SR 3/US 41/COBB PARKWAY WIDENING FROM PACES MILL ROAD TO AKERS MILL ROAD

STP00-0001-05(047), P.I. No. 721152

Value Engineering Study Report

March 2011

REVISION DATES

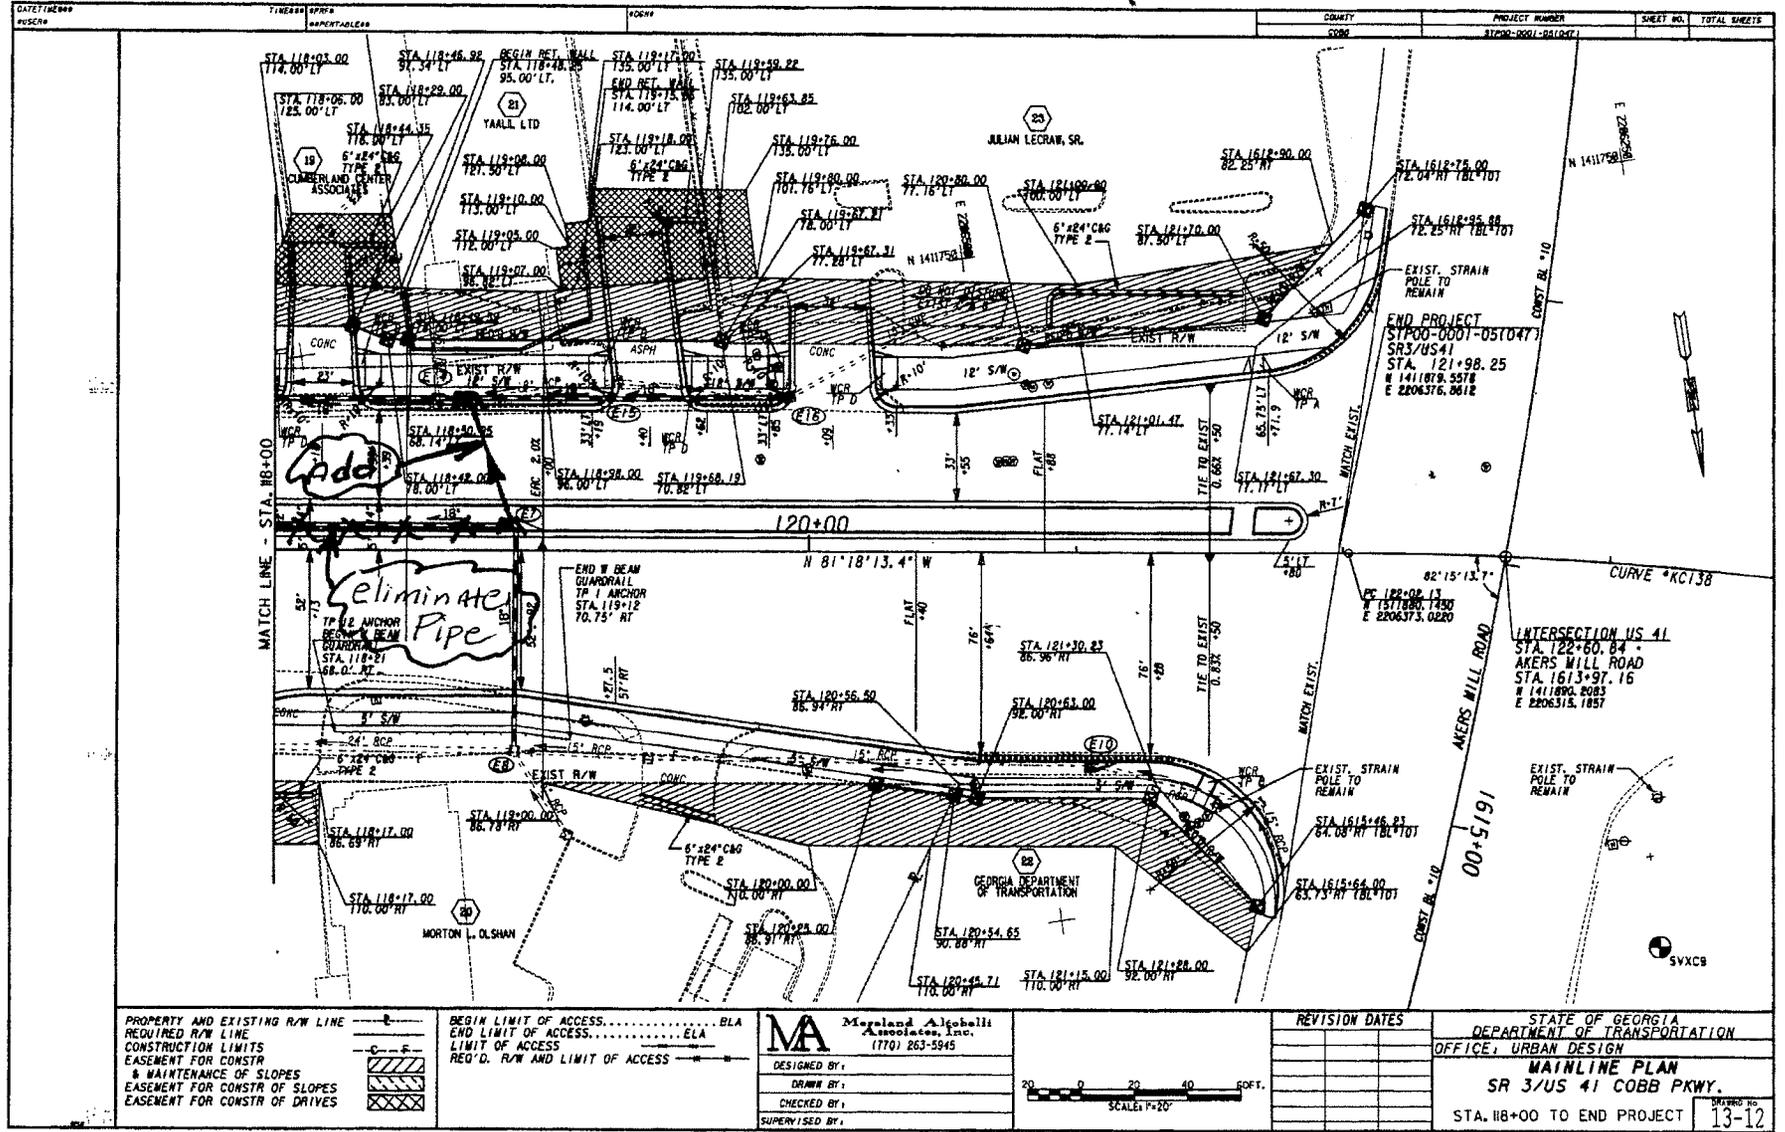
There are several long parallel runs of longitudinal pipe that could be drained into one system by using cross-drain pipes for structures in the median or located on the opposite side of the roadway. Since there would be one system under the alternate design, a portion of the pipe would increase in size.
